BAR 21-08-02

735 Northwood Avenue, TMP 340078000

Project: Replace asphalt shingle roof with standing-seam metal, install PV panels

**City of Charlottesville
Board of Architectural Review
Staff Report
August 17, 2021**

Roof Perspectives

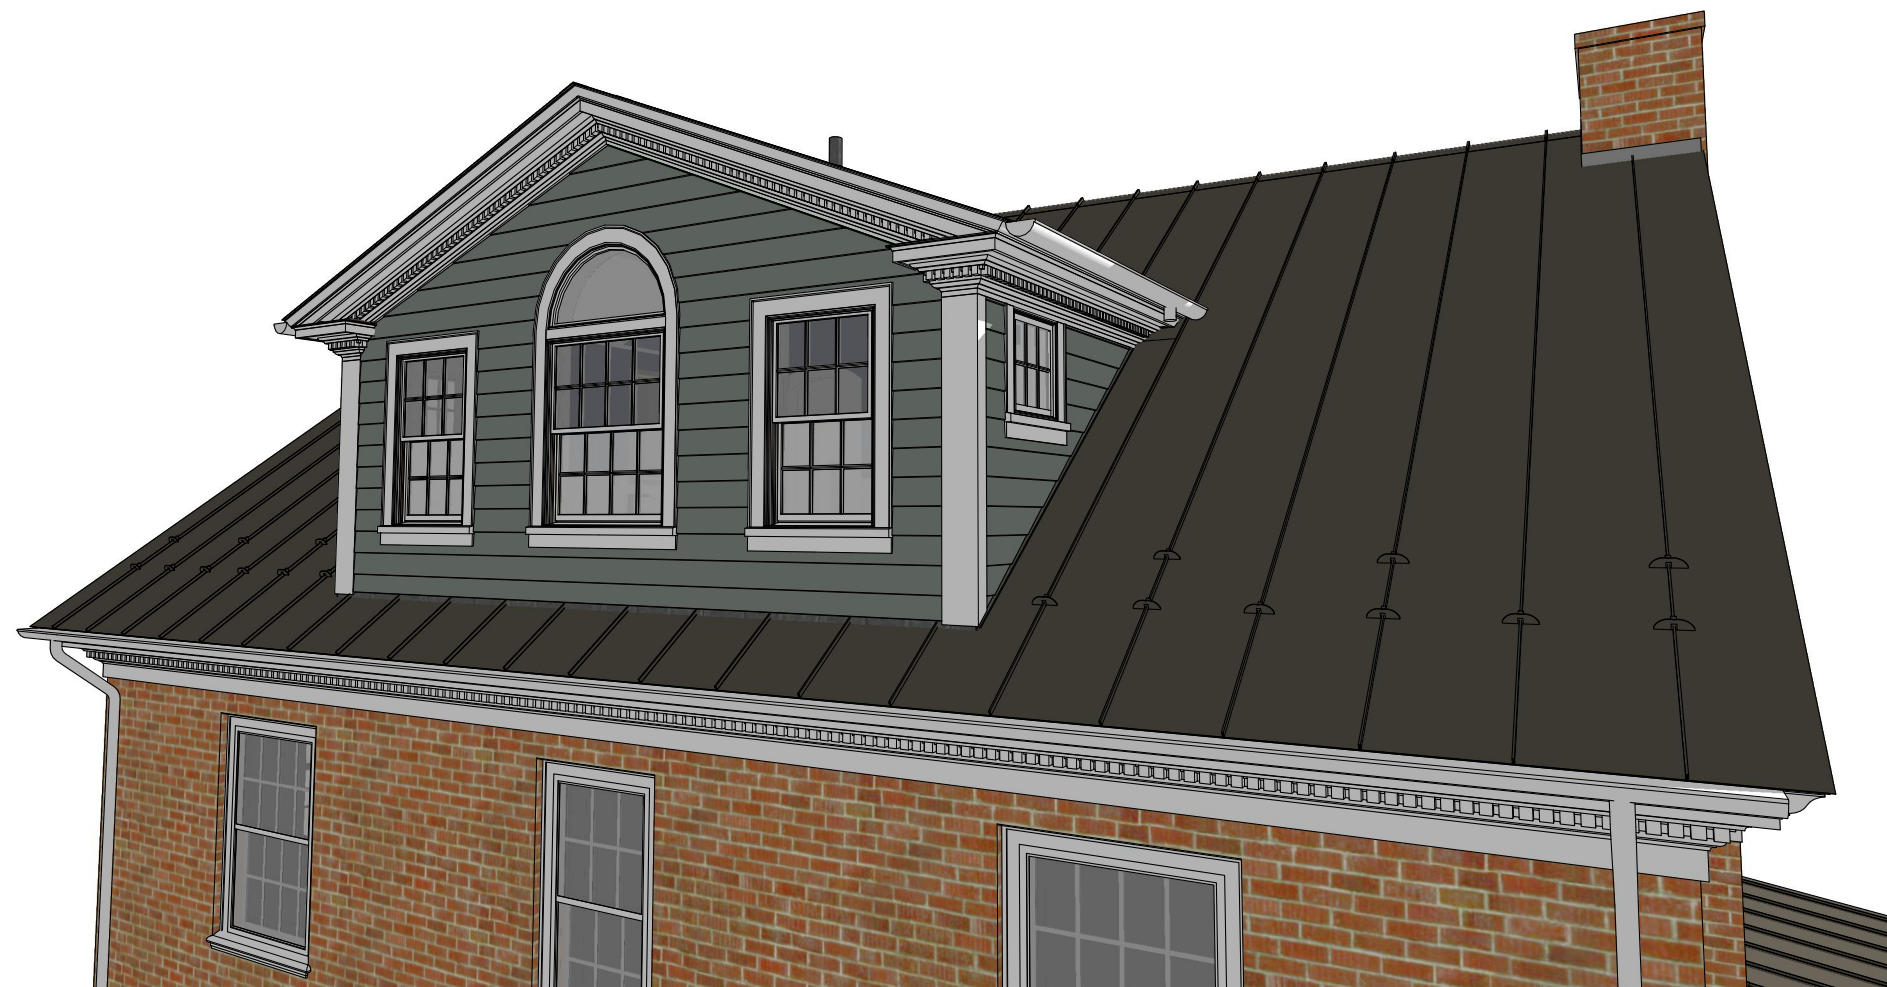
Given the above and that the Design Guidelines are intended to provide flexibility, with an acknowledgement that sustainable and green building design is complimentary to the goals of historic preservation, staff suggests this CoA can be approved, provided the BAR expresses that the alternatives are limited and less-preferable, and with the following conditions:

- the PV panels will not damage or interfere with the new roof;
- any associated PV equipment—boxes, cables, etc.—will be located to the side or rear of the house and properly screened.

- Q: Proposed pan-width, seam height, and roof color?
- The BAR typically applies a condition that the ridge of the standing-seam metal roof be hand crimped, and not have commercial-looking ridge caps or ridge vents.

- The BAR typically applies two conditions:
 - the PV panels will not damage or interfere with the roof (so they will ask about the connections);
 - any associated PV equipment—boxes, cables, etc.—will be located to the side or rear of the house and properly screened.

Carl Schwarz moves: Having considered the standards set forth within the City Code, including the ADC District Design Guidelines, I move to find that the proposed metal roof and PV panels at 735 Northwood Avenue satisfy the BAR's criteria and are compatible with this property and other properties in the North Downtown ADC District, and that the BAR approves the application as submitted.

The clients have selected Englert Matte Black low gloss for the roofing, I can provide a sample if necessary. The gutters will be reinstalled as white (current gutters are white) half round with round downspouts (currently k-style and rectangular) and I could possibly also provide the roofers spec for that.

Re the PV panel roof connections I will confirm the attachment method. We plan to have a conduit from the PV panel through the roof and interior of the house to the location of the batteries, which will be located under the existing rear concrete and brick deck in a fully enclosed area, so other than the panels there shouldn't be any externally exposed equipment.
